BASIC PERMIT PACKAGE
REVIEWED FOR CODE COMPLIANCE
WITH IRC 2015
KITSAP COUNTY BUILDING DEPARTMENT

a new model home for
Disney & Associates

Plan 2322

3 MIDDLE WALL SECTION
1/2" = 1'-0"

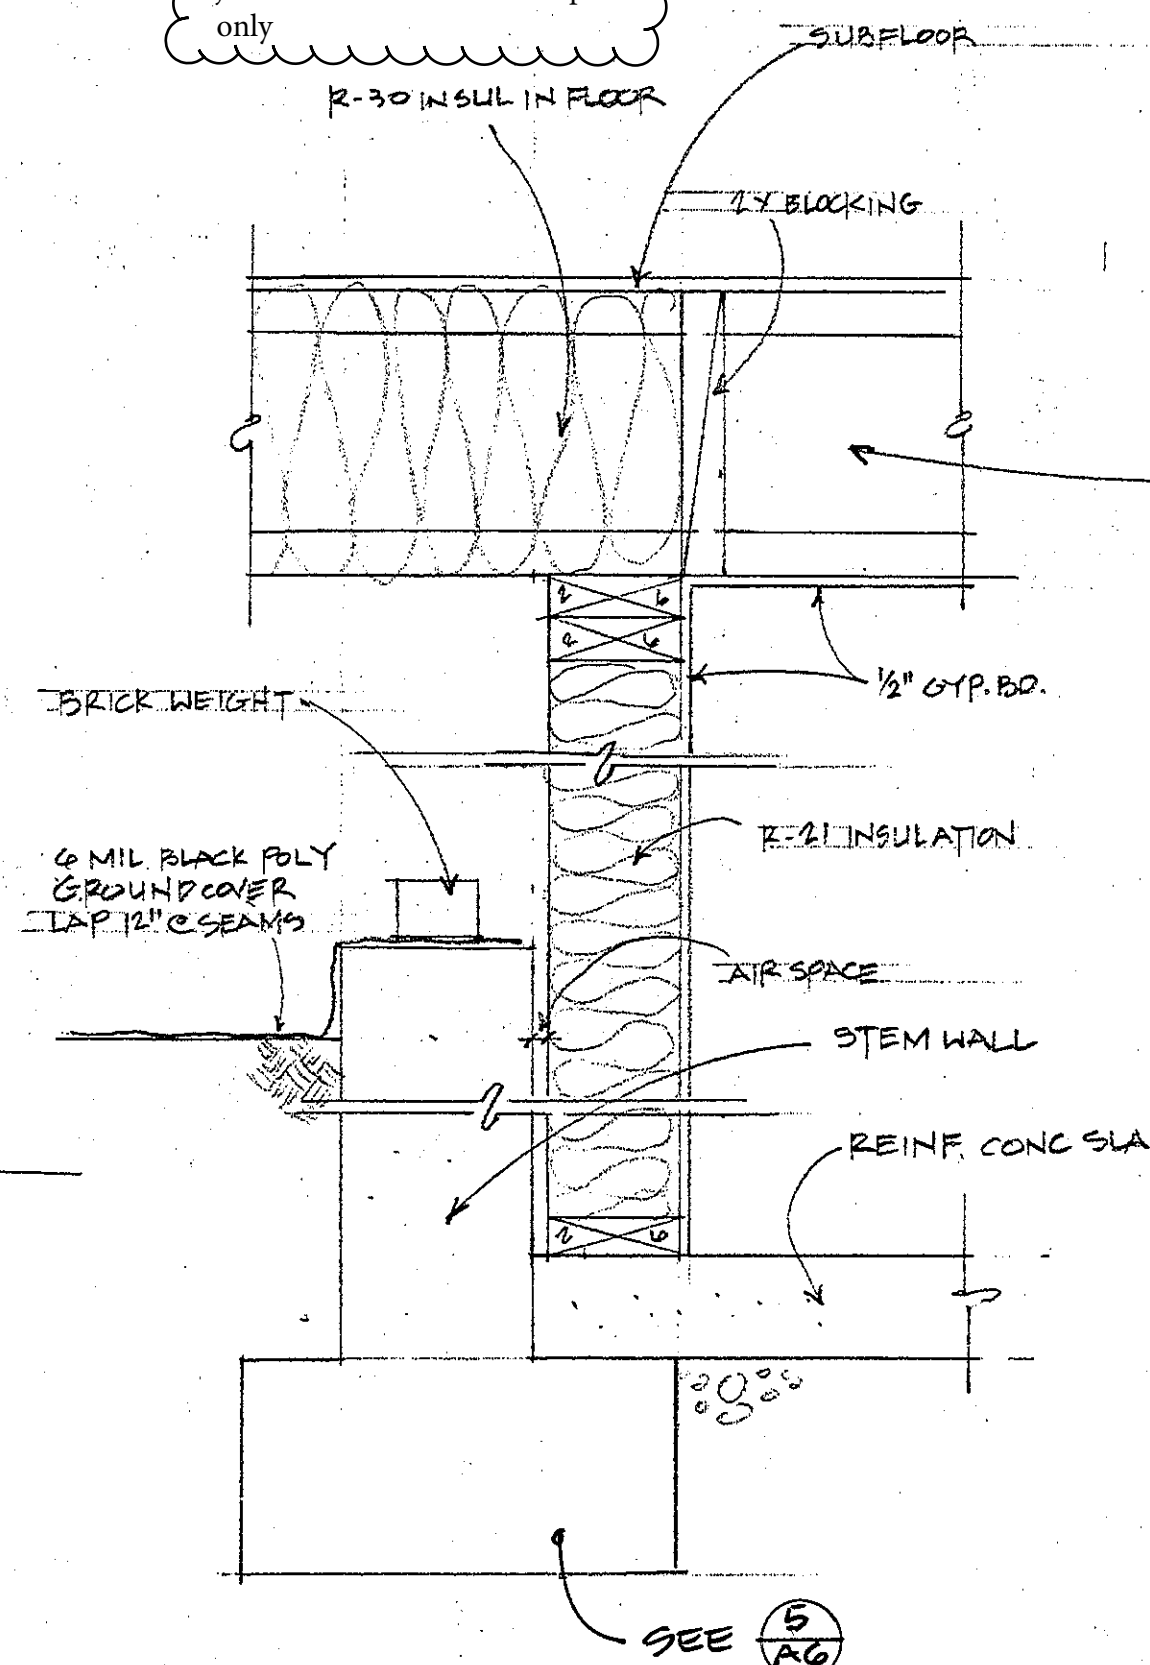
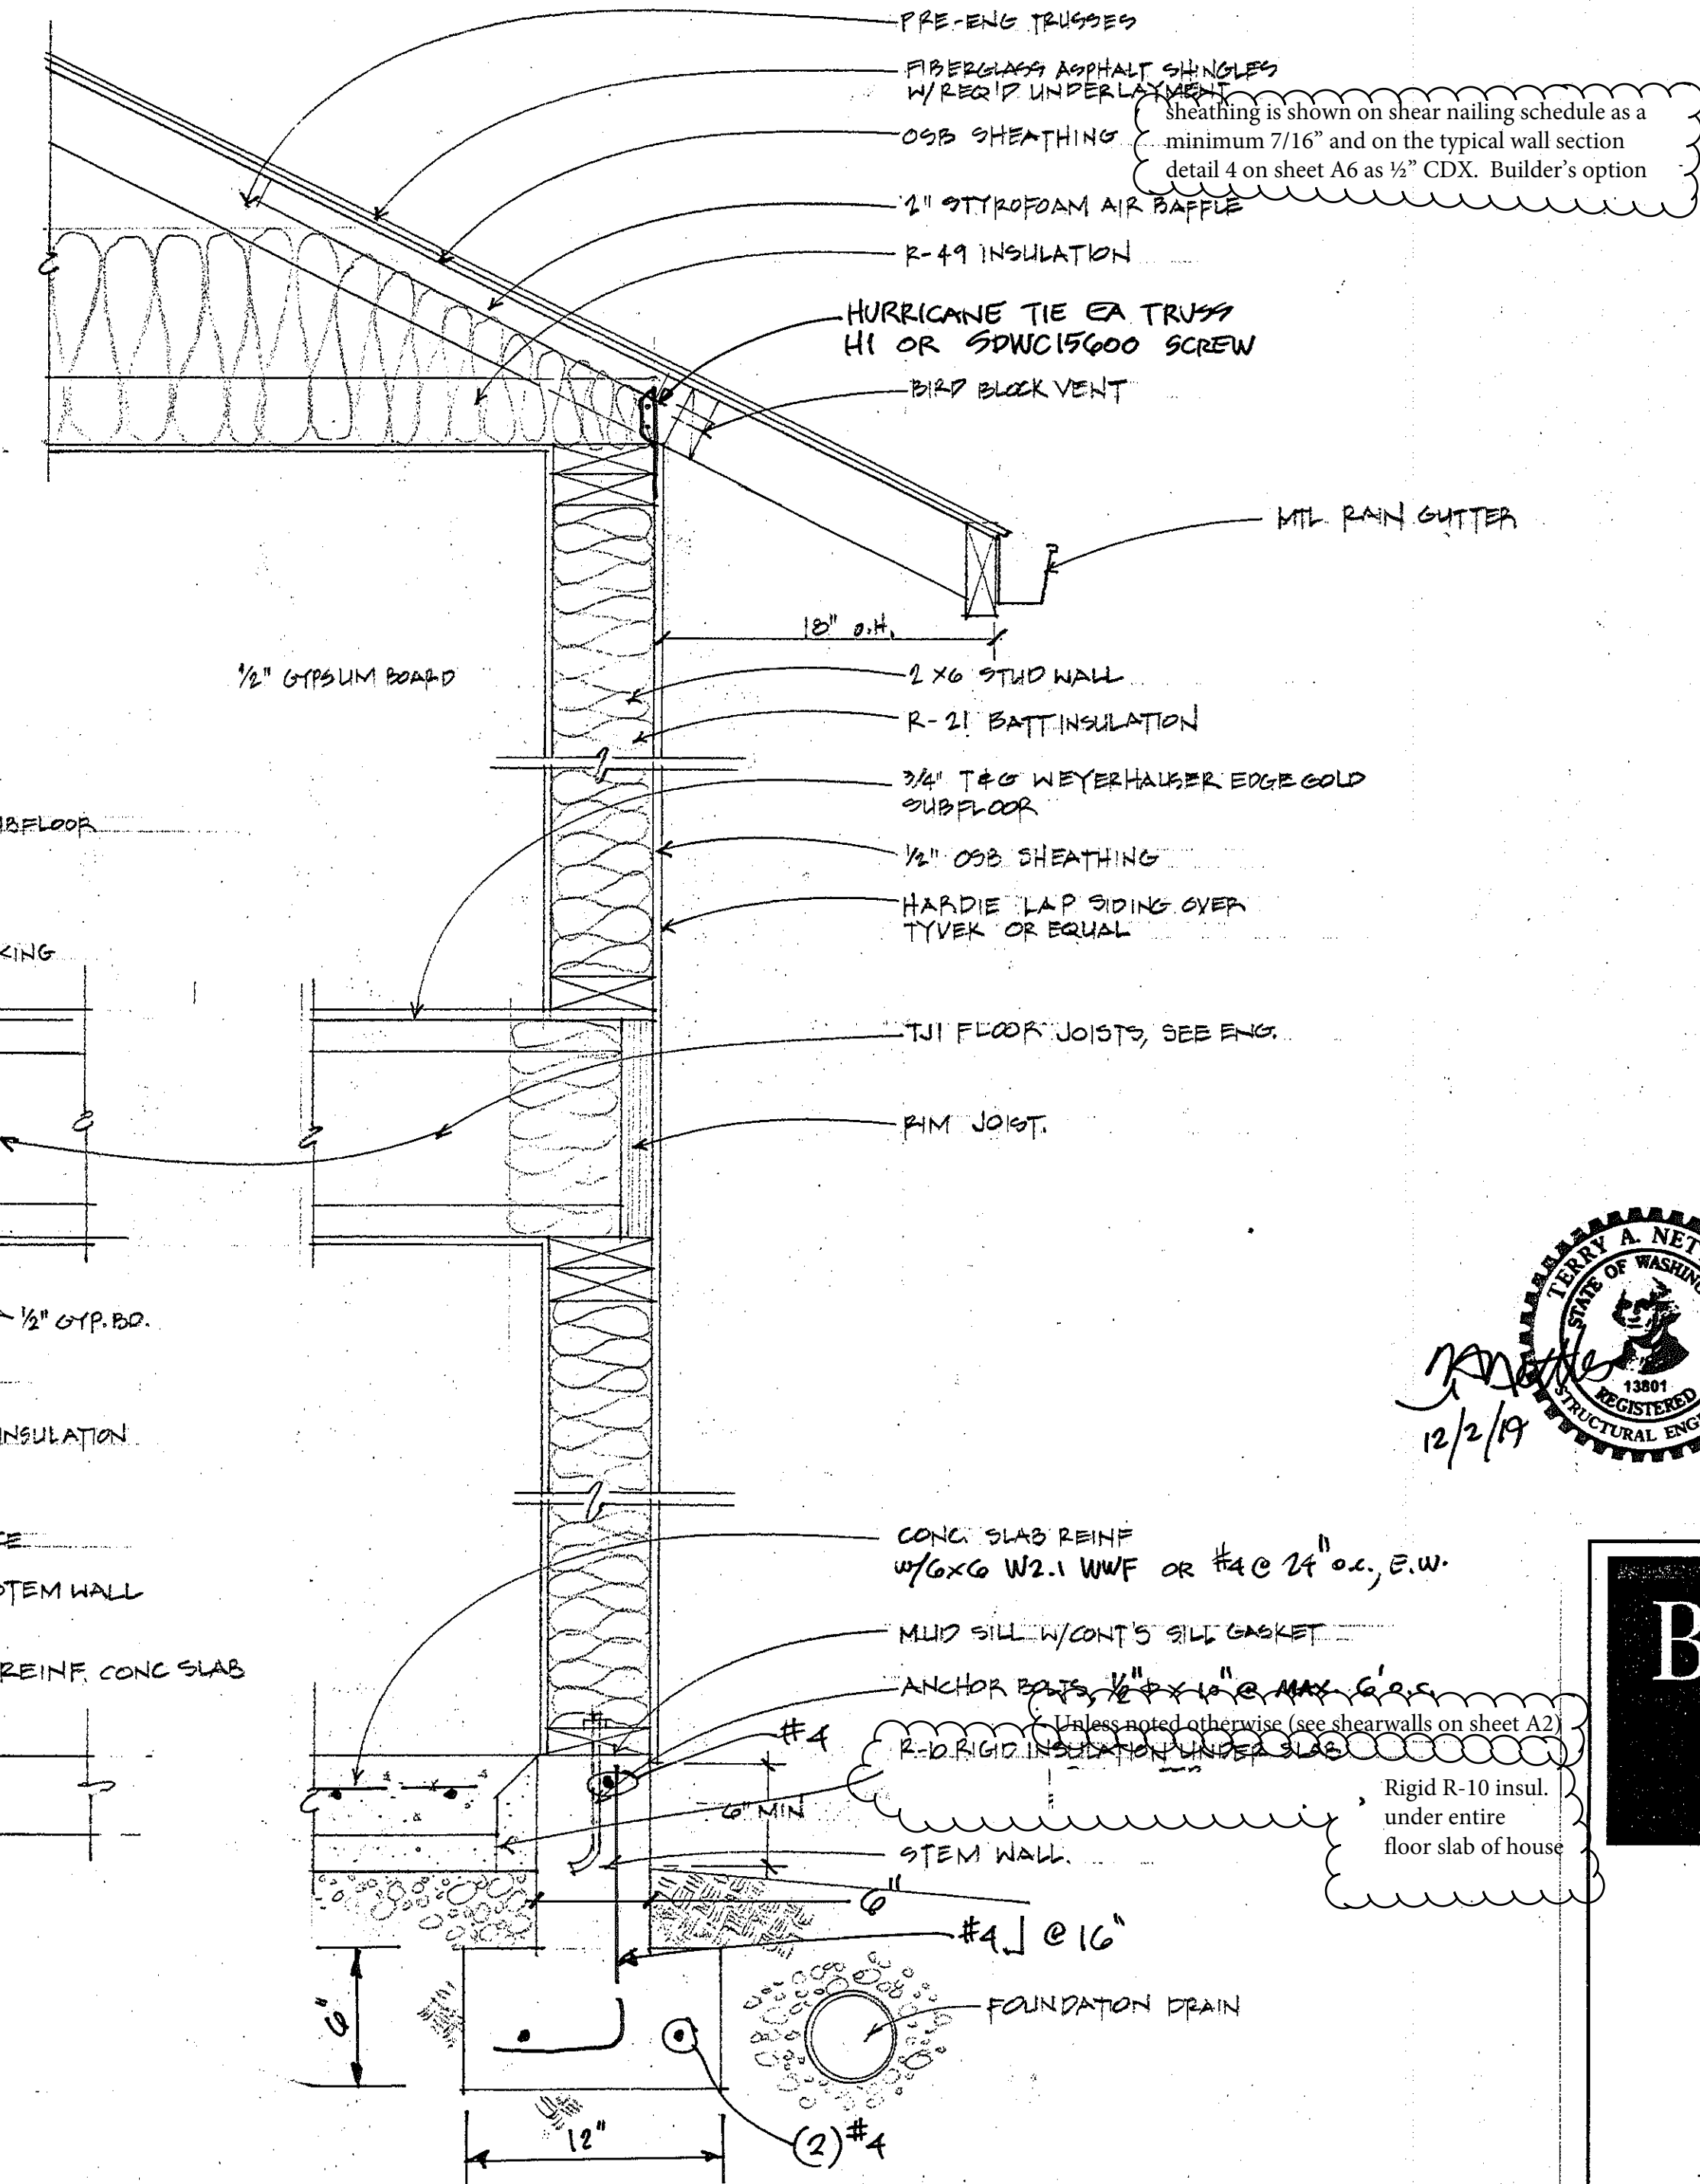
R-38 insulation required in floor
joists over unheated crawl space
only
R-30 INSUL IN FLOOR
